SERVICE BULLETIN No.1152

COACH MODEL	: C2045
BULLETIN TYPE	: Safety Recall Program – NHTSA Campaign number 04V-423
MANUAL & SECTION	: N//A
DATE	: December 3, 2004
SUBJECT	: Air tank retention
TERMS & CONDITIONS	: Refer to the Warranty Information in this Bulletin.

Figure 1a: Air tank bolt-on assembly – drive axle area

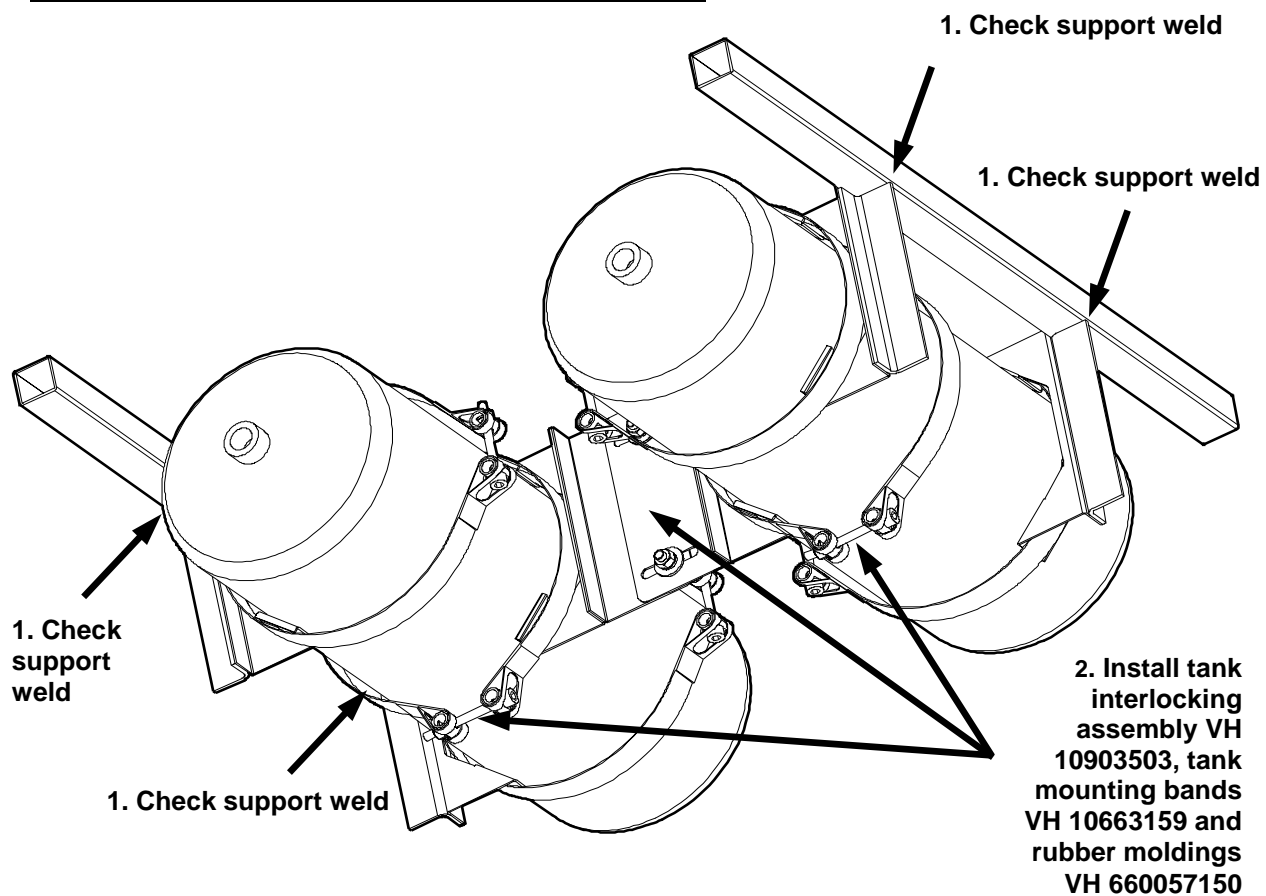
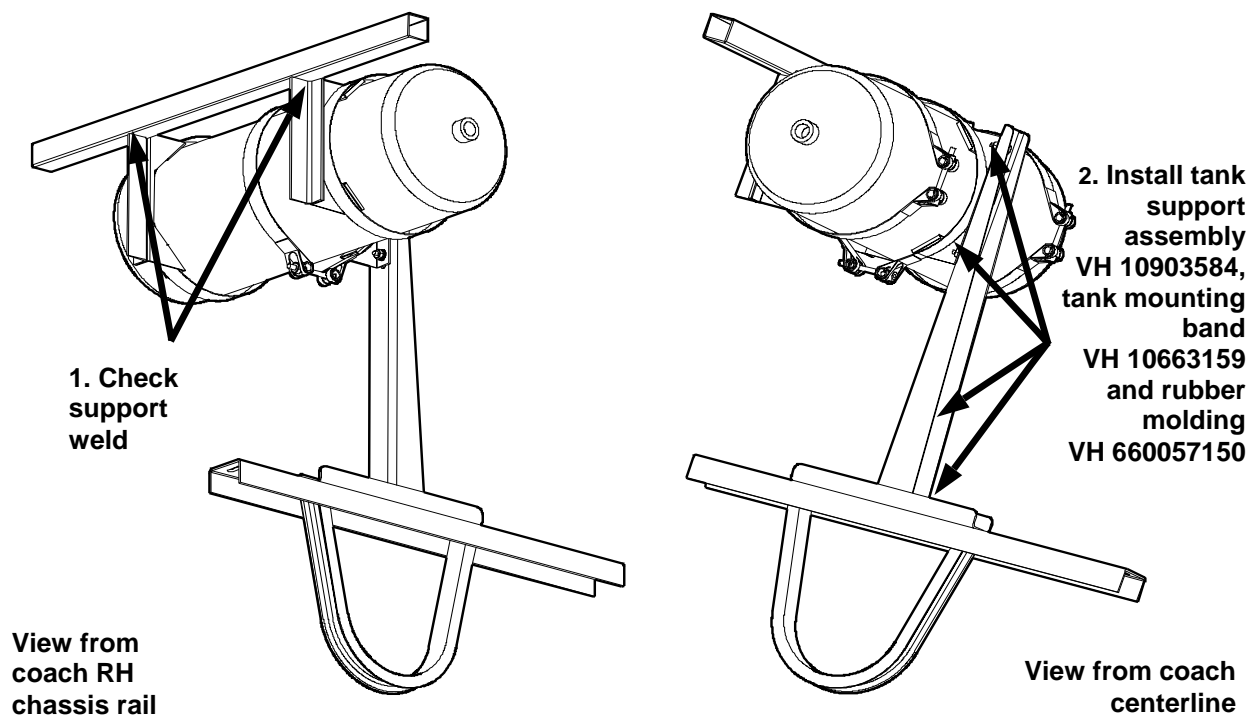
1. On the above-mentioned coaches, it is necessary to check the air tank retention and to install additional support brackets to ensure that the air tanks listed hereafter remain properly secured to the chassis.

2. This Service Bulletin offers a bolt-on solution to address the issue. Refer to the parts list and the procedure, which provide the information required to complete the repair.

Bolt-on repair assemblies – order as kit VH 10907587 (see Figures 1, 2 and 3):

Figure 2: Tank interlocking assembly VH 10903503 for auxiliary and drive axle service brake tanks

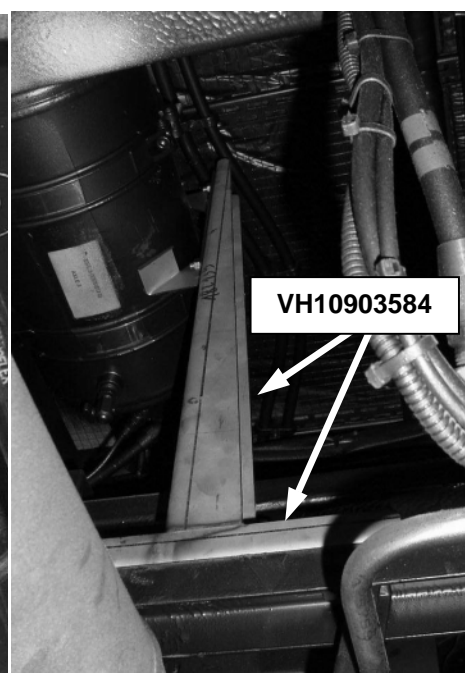
- 1) Assemble the interlocking assembly halves and the accompanying fasteners for a loose fit.
- 2) Install the interlocking assembly between both air tanks (1 and 2, Figure 11).
- 3) Using two tank mounting bands and rubber moldings (3 and 4 Figure 11), secure each one of the interlocking assembly halves to tank #1 and tank #2 respectively. Secure the bands hand tight with the Allen bolts (5 and 6, Figure 11). Figure 12 shows one half of the assembly.
- 4) Tighten interlocking assembly bolts (7 and 8, Figure 11) to a torque of 15 ft.lbf (20 Nm).

Figure 7: Air tank location

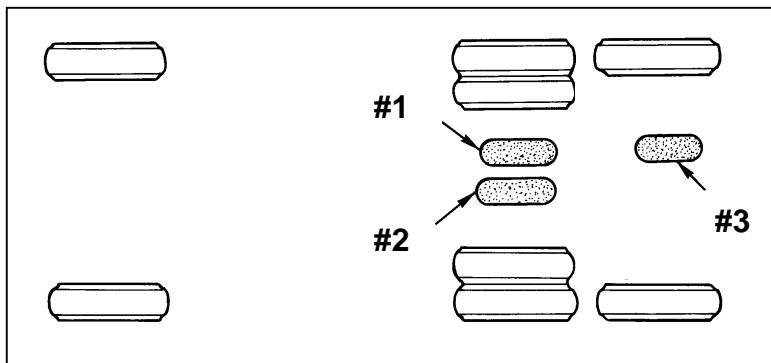
Tank	Location	Refer to
#1 Auxiliary	Above drive axle	1, Figure 7 (page 5 of 10)
#2 Drive axle service brake	Above drive axle	2, Figure 7 (page 5 of 10)
#3 Tag axle brake	Above tag axle	3, Figure 7 (page 5 of 10)

- 4) Locate the affected air tanks (see 1, 2 and 3, Figure 7, Figure 8 and Figure 9).

Figure 10: Air tank support bracket weld area

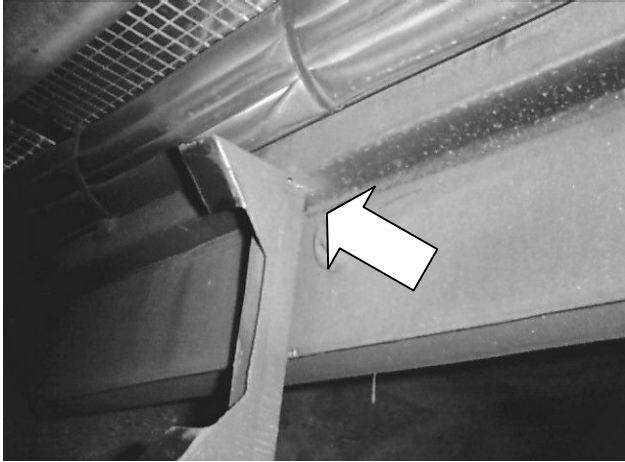
- 1) Using a flashlight, inspect the area where the air tank support brackets have been welded to the chassis rails (see Figures 1a and 10).

- 2) Slipping a prybar between the air tanks and the chassis, exert moderate lateral pressure on air tanks #1, #2 and #3.

NOTE: If there is any damage to the brackets and/or to the chassis rails in the support bracket area (cuts, tears, cracks), contact your nearest ABC Customer Care & Parts Source dealership for assistance.
